**CITY OF NEWARK
DELAWARE**

**CITY OF NEWARK
WATER MAIN RESTORATION 2023
CONTRACT NO. 23-02**

**ADDENDUM 3
October 20, 2023**

PATTERNED CROSSWALK
NOT TO SCALE

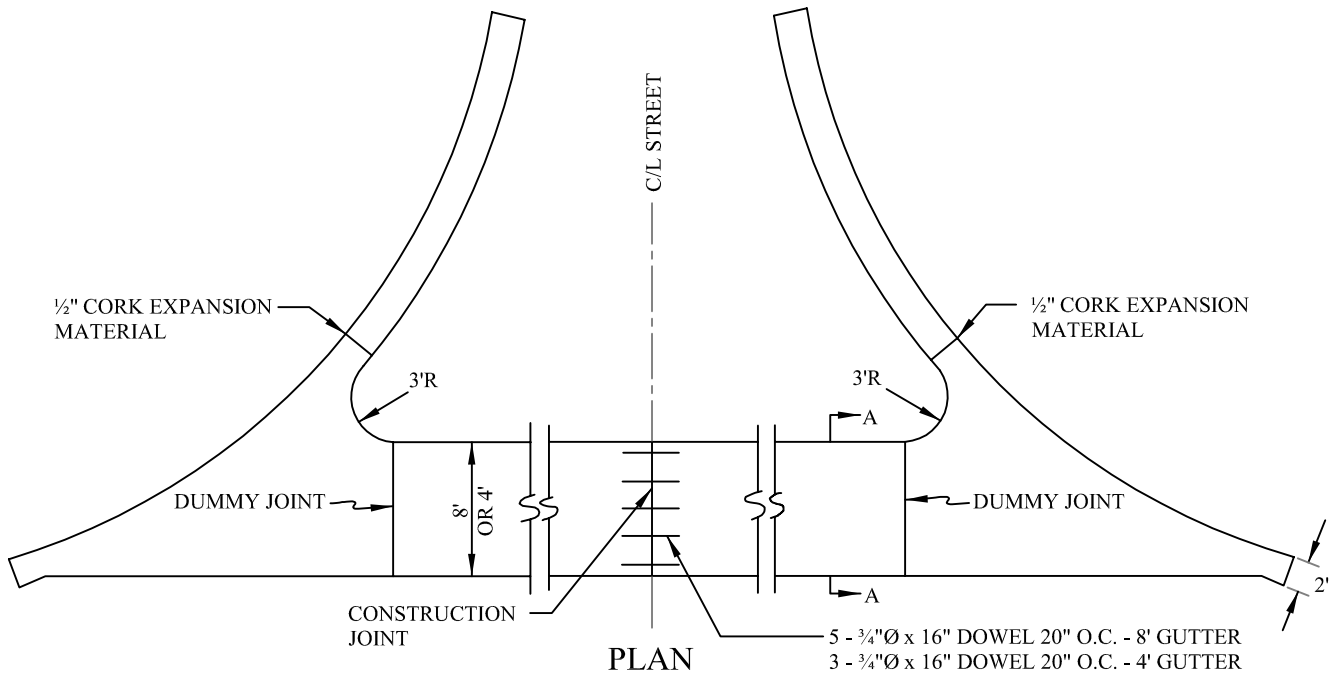
Question 9:	In the intersection of Trye Ave and East Main Street there is an existing brick painted crosswalk striping, are we to restore all these markings to mill and overlay of street. Can you clarify to what extent this striping needs to be replaced.

Response 9:	Restoration of roadway surface, pavement markings, and striping shall extend to the limits of the mill and overlay shown on the plans. Detail for the patterned crosswalk is attached to this addendum.

Valley Gutter - Details

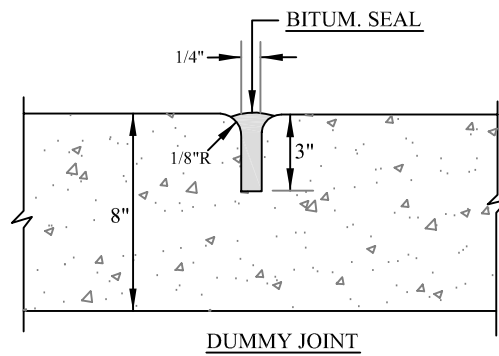
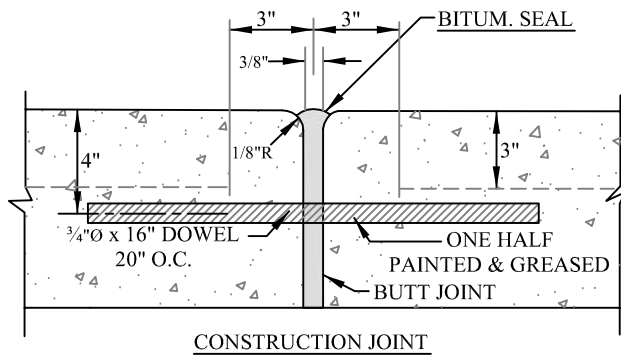
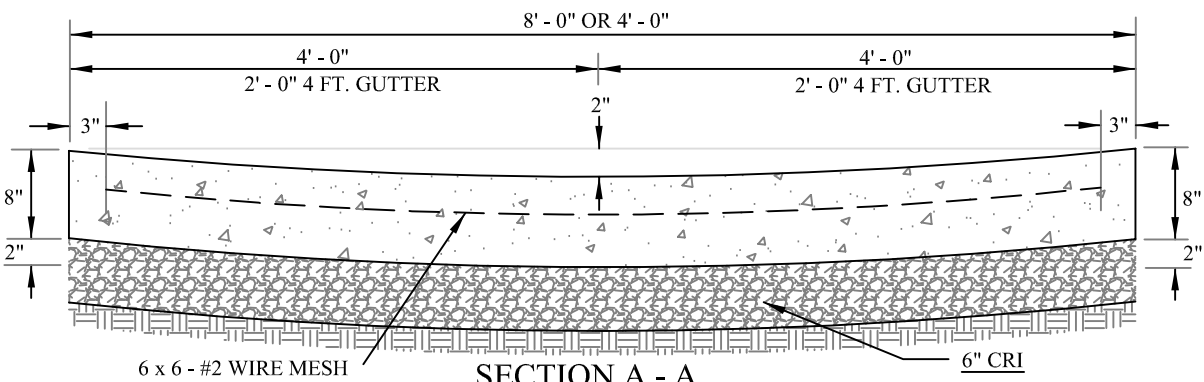
Response 15:	City of Newark Public Works and Water Resources Inspector will verify bedding conditions before backfill.
Question 16:	Can you include concrete details for the replacement of bid item Valley Gutters.

Response 16:	Attached to this addendum.
Question 17:	Can you explain what the need for the 8" cut and cap with a blowoff on SR2 is. Is the blow off being used for another purpose we are not aware of.
